PROJECT NAME: Murphy Cadotte / 1780

VENDOR NAME: Canadian Water Technologies / 1780-005

DOCUMENT
DESCRIPTION: Process & Instrumentation Diagram

VISTA MURPHY CADOTTE -1780
PROCESS & INSTRUMENTATION DIAGRAM
WATER TREATMENT PACKAGE PKG-6000

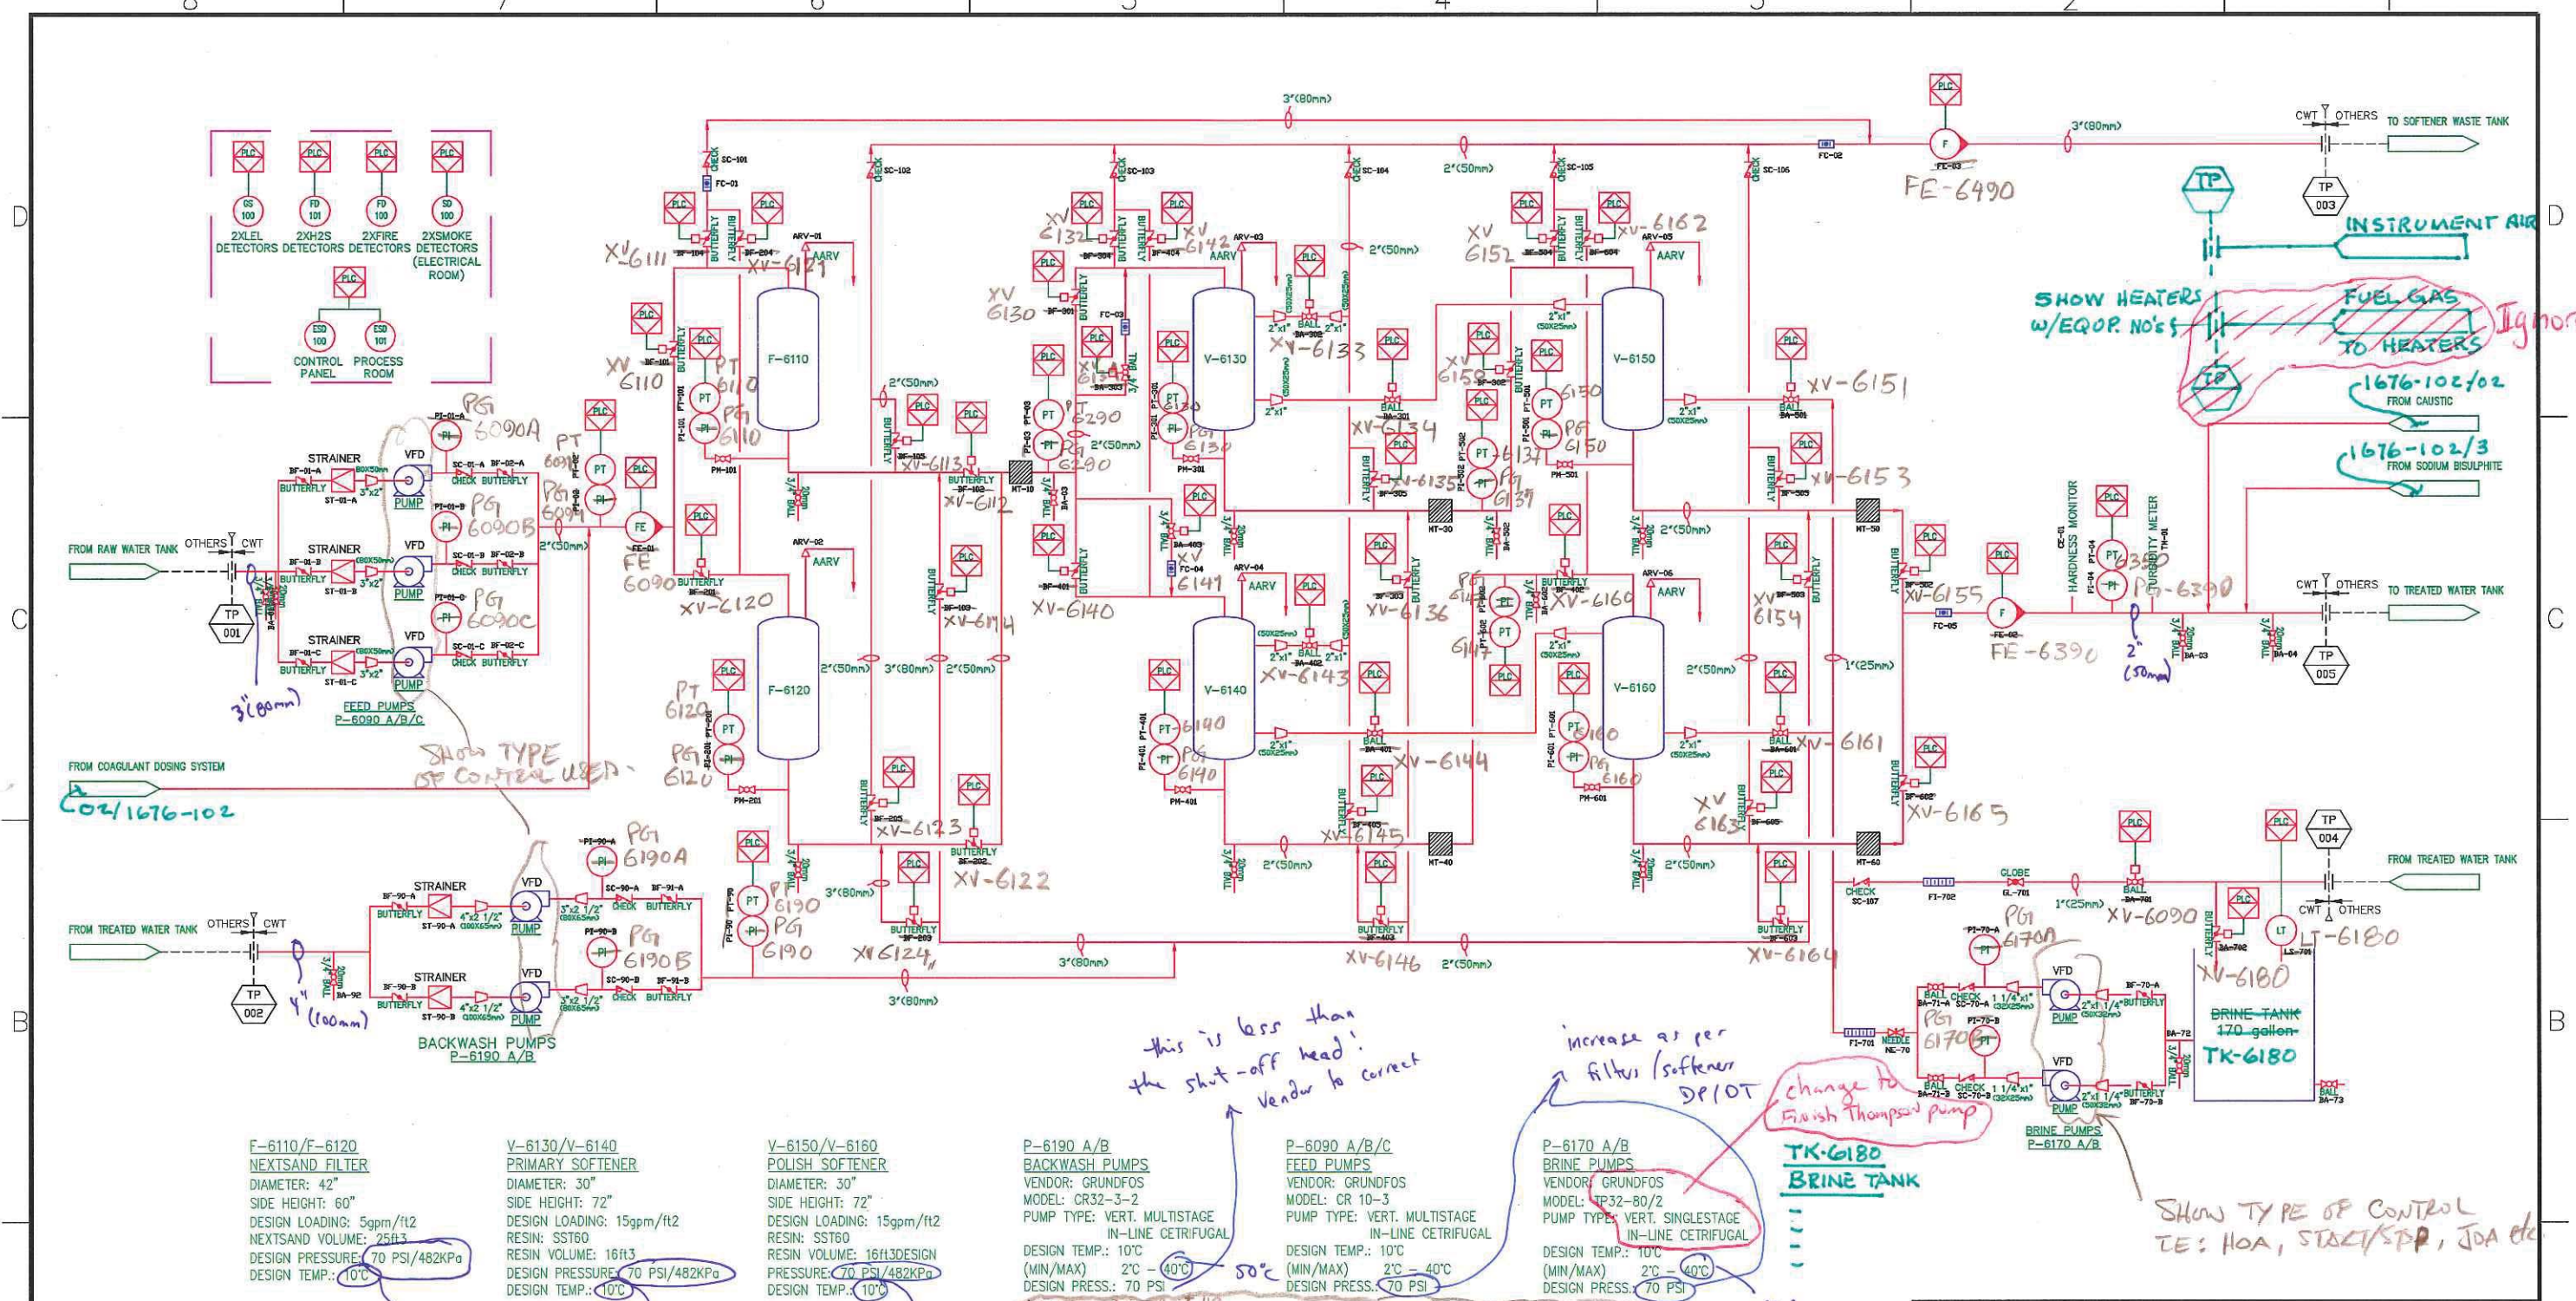
SHOW TYPE OF CONTROL
TE: HOA, START/STOP, JDA etc

need to be increased
as per P-6190A/B shut-off head.

this is less than
the shut-off head!
Vendor to correct

increase as per
filter/softener
DP/OT

change to
Finish Thompson pump

PROVIDE DRIVER DATA SUCH AS MOTOR, MOTOR VOLTAGE, & HP RATING.

See email for recommendation

VISTA MURPHY CADOTTE -1780
PROCESS & INSTRUMENTATION DIAGRAM
WATER TREATMENT PACKAGE PKG-6000

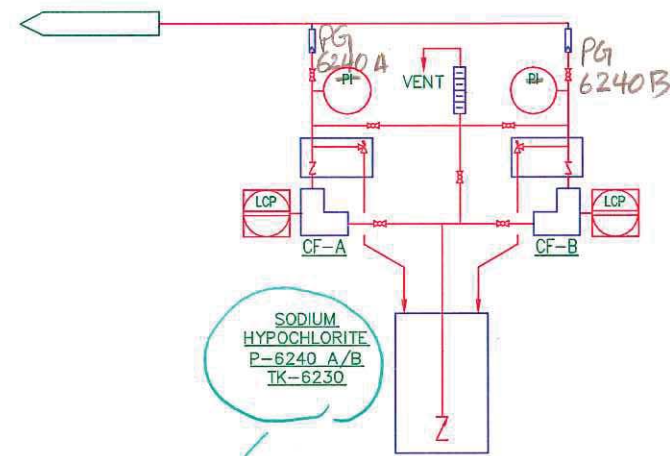
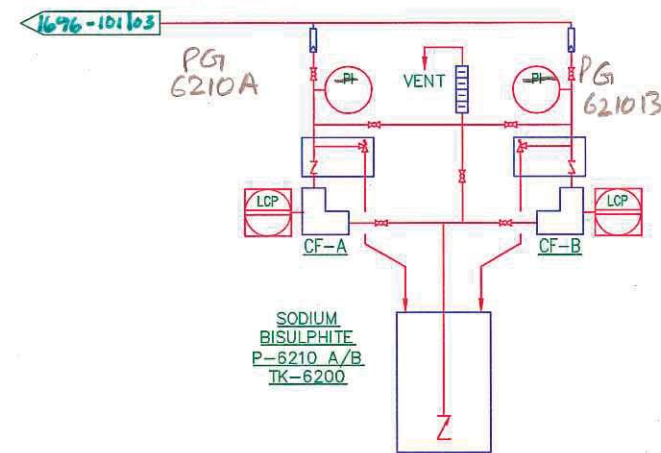
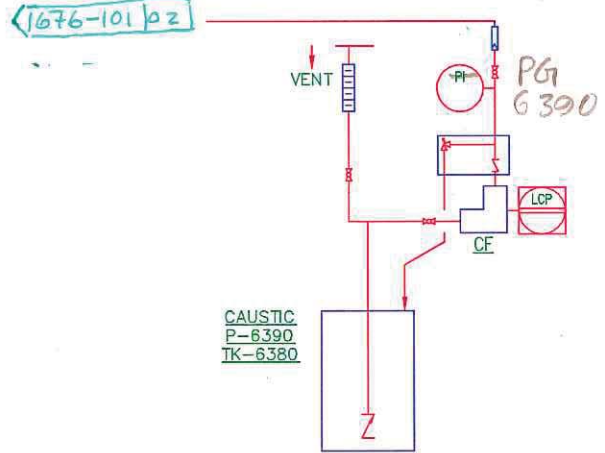
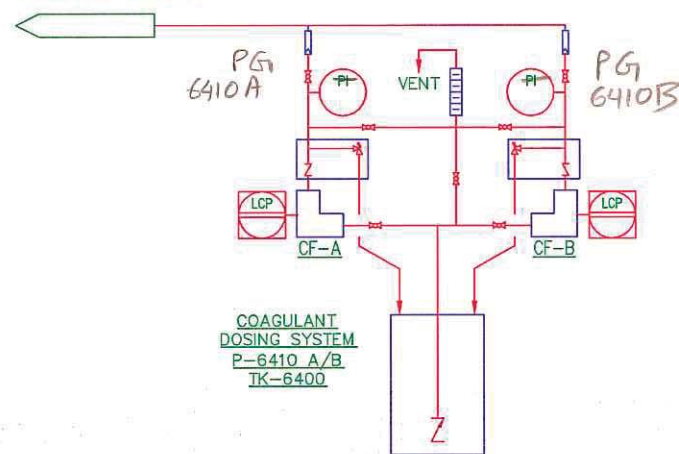
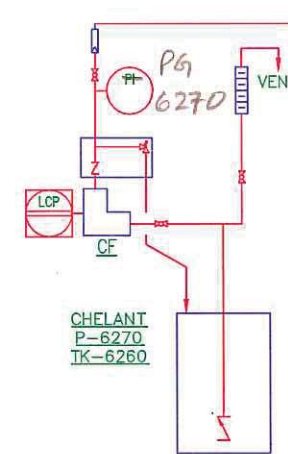
P-6240 A/B
SODIUM HYDROCHLORIDE
TK-6230
SODIUM HYDROCHLORIDE TANK
CF-A/B
?
TYPICAL

ALSO PROVIDE DRIVER DATA
SUCH AS: MOTOR TAE, MOTOR VOLTAGE & MOTOR HP RATING.
ALSO SHOW TYPE OF CONTROL FOR MOTORS.

PLAN VIEW

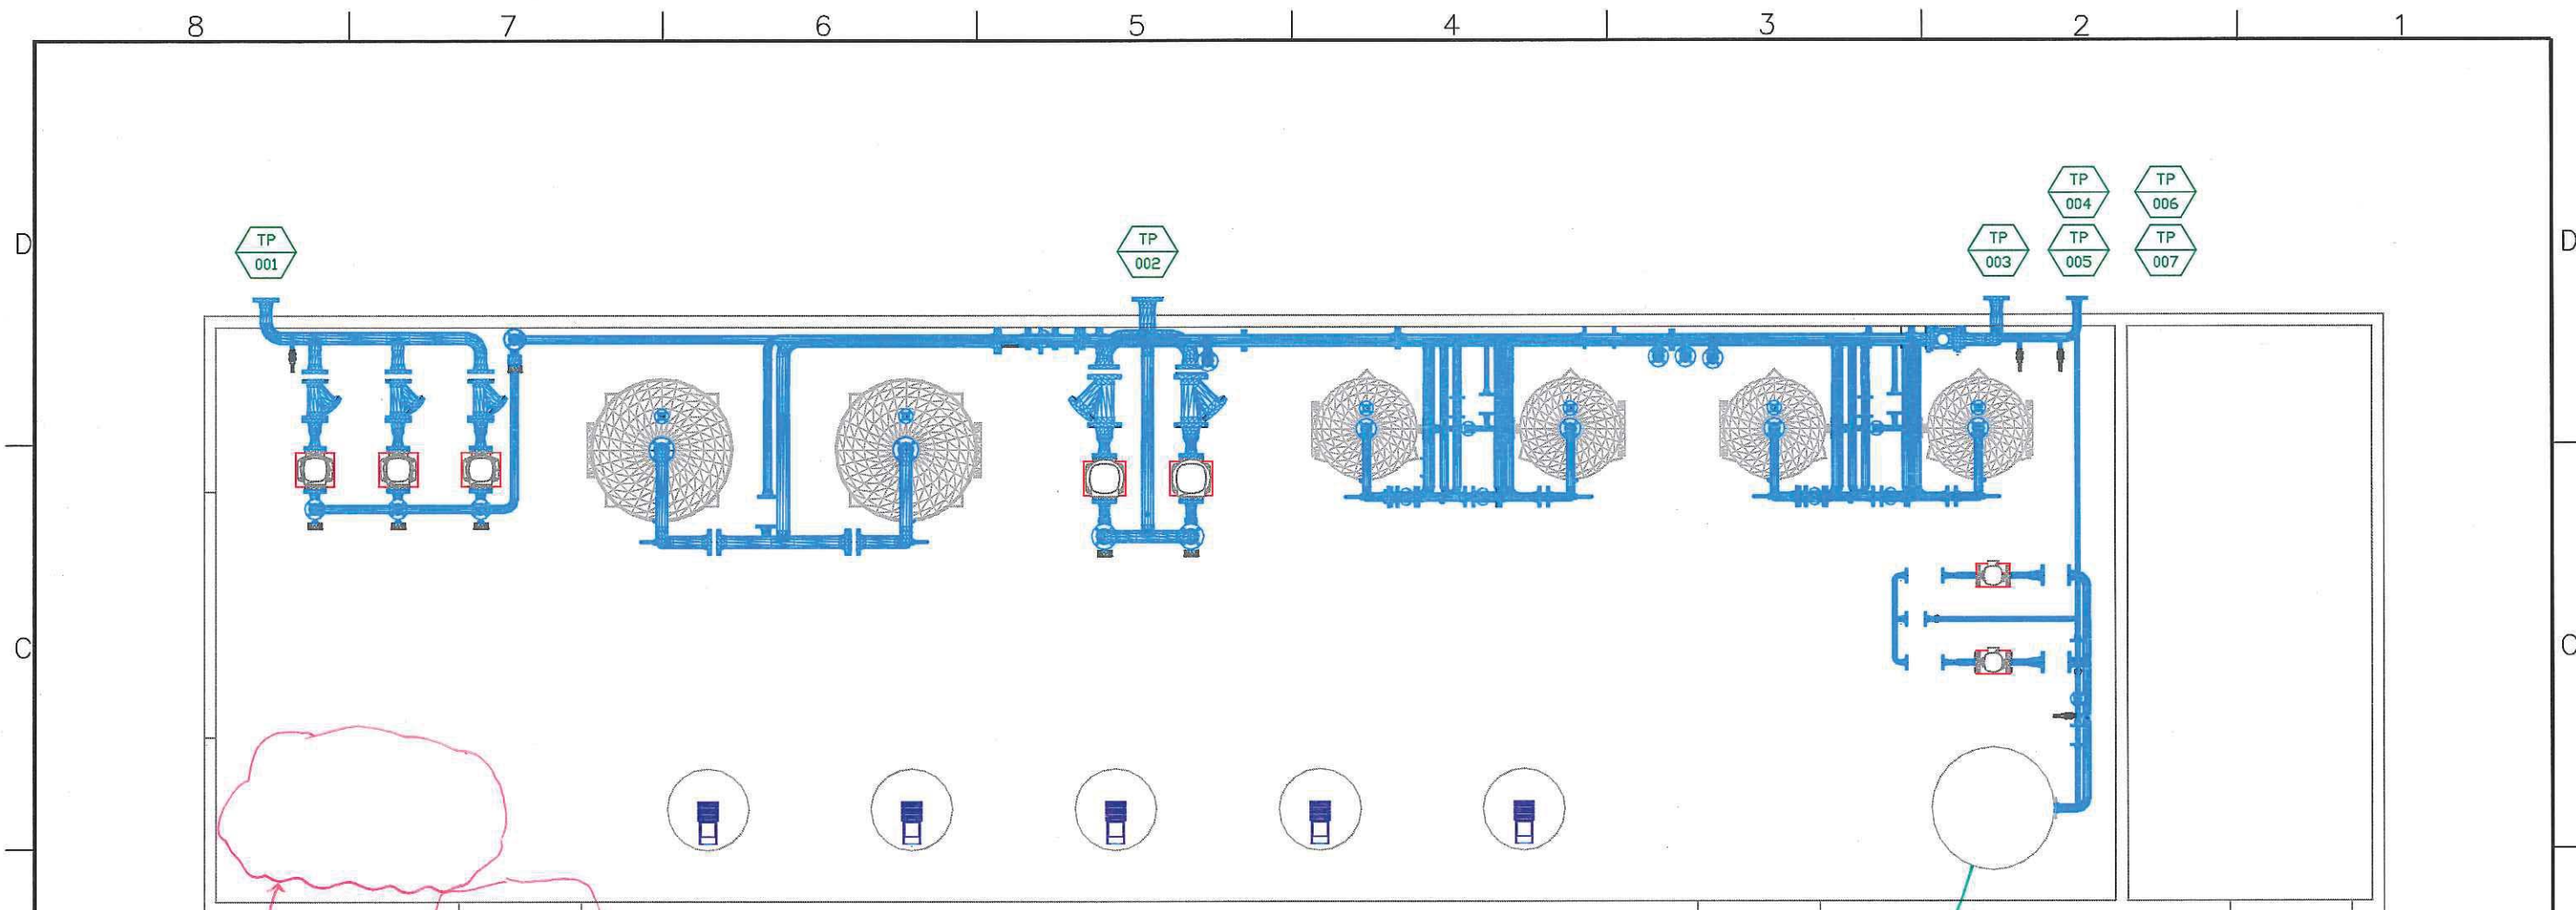
TANK DIAMETER LARGER THAN SHOWN ON DWG. 1676-201 (Ø 24'0")

Relocate Brine System (tank and pumps) Here

Does this opening NEED to shift over to allow some room for Brine system?

DOCUMENT
DESCRIPTION: Building Lighting Layout

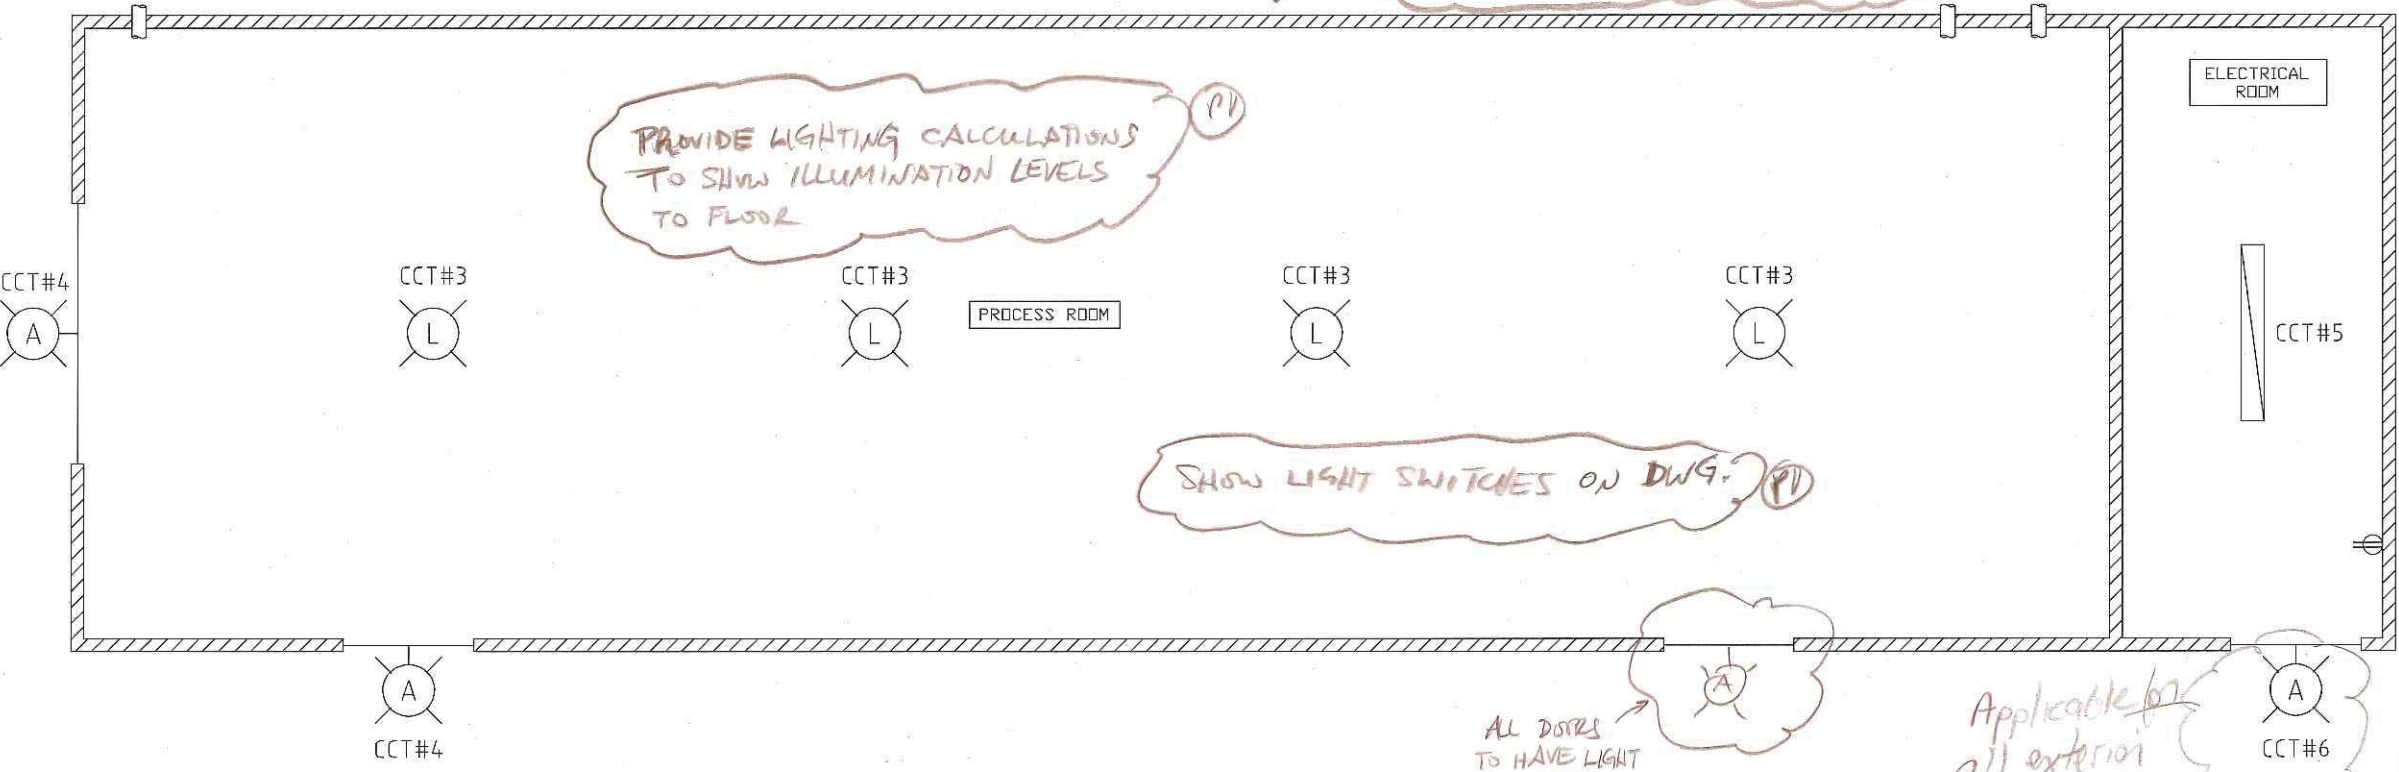
ALL DRAWINGS MUST HAVE DIMENSIONS IN MM & PROPERLY SHOWN ON DWG & DWG TO BE TO SCALE.

MUST SHOW GROUNDING/BUNDLING ON LAYOUT DWG THROUGHOUT BUILDING & GND BUS BAR IN MCC ROOM. ALSO PROVIDE ISOLATED GND BUS FOR PLC & INSTRUMENTS & OTHER SENSITIVE ELECTRONIC EQUIPMENT.

Vendor to supply exterior fixtures. Power & control will be from B-1100 mcc Building.

unable to locate cut sheet for this part #

photocell is not required. Fixtures will be controlled by contractor panel in B-1100 mcc Building.

VENDOR TO INDICATE THIS IN A NOTE ON THIS DWG.

DRAWING TITLE
**BUILDING
EMERGENCY LIGHTING
LAYOUT**

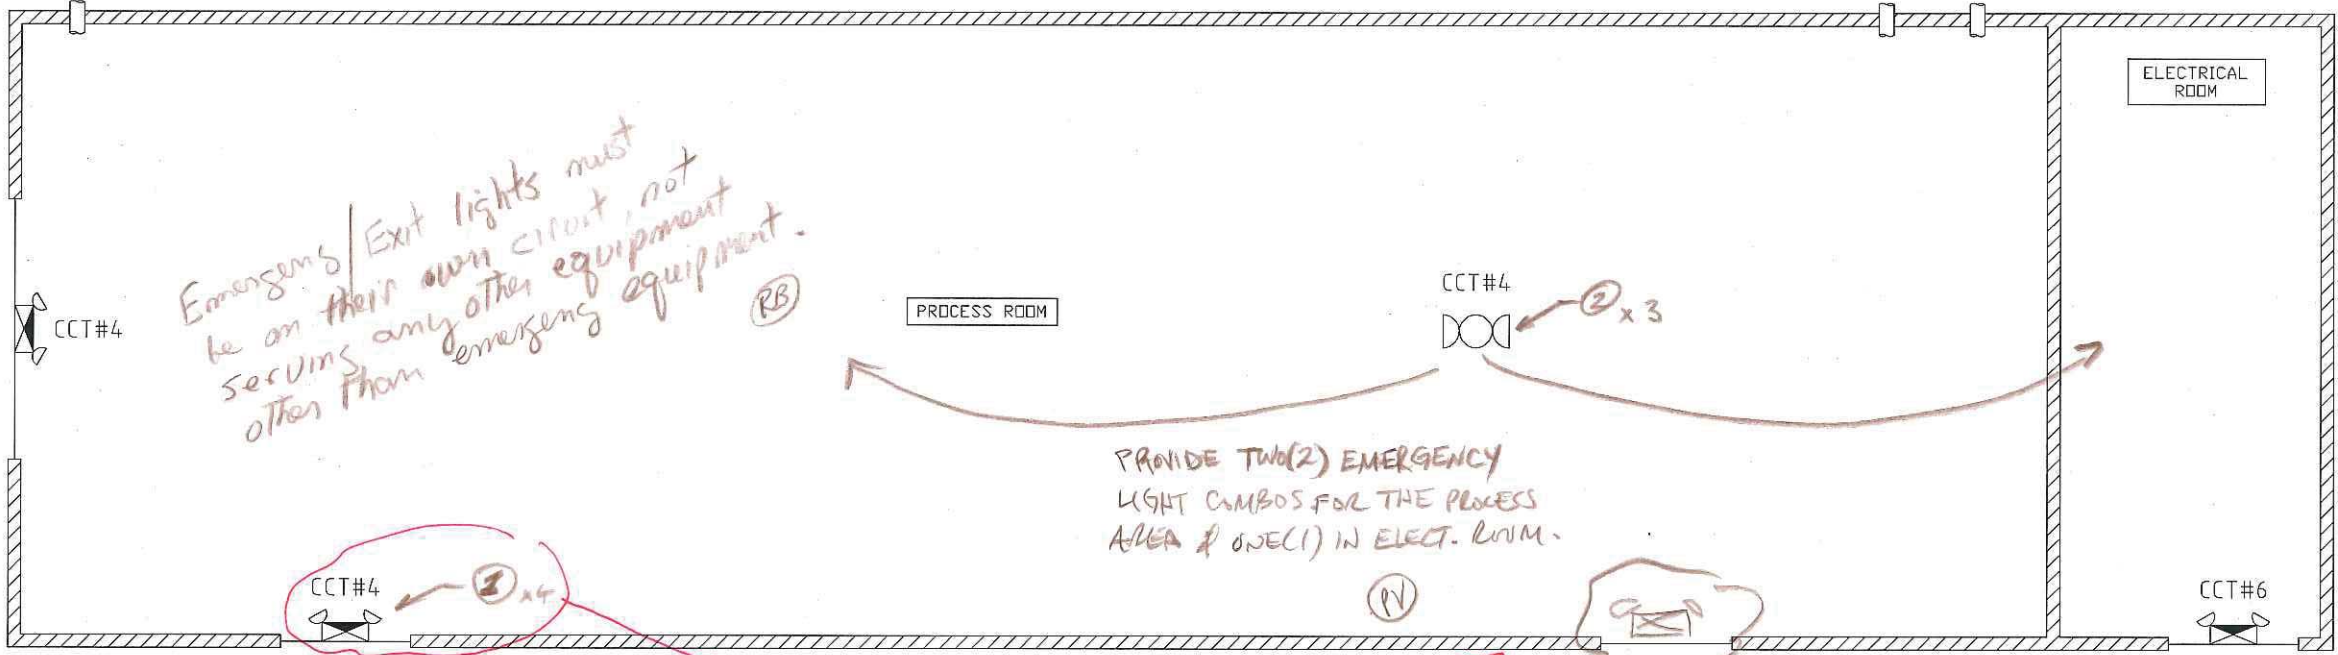
provide with
battery backup
minimum.

Complete B.O.M.
not a classified
fixture.

Emergencies/Exit lights must
be on their own circuit, not
serving any other equipment
other than emergency equipment.

PROVIDE TWO(2) EMERGENCY
LIGHT COMBOS FOR THE PROCESS
AREA & ONE(1) IN ELECT. ROOM.

EACH DOOR MUST HAVE
EXIT SIGN TO CODE

This opening NOT AN EXIT (EMERGENCY SHOWER)

ALL DWG'S MUST HAVE DIMENSIONS IN MM
& APPLIED TO DWG & DWG TO BE TO SCALE.
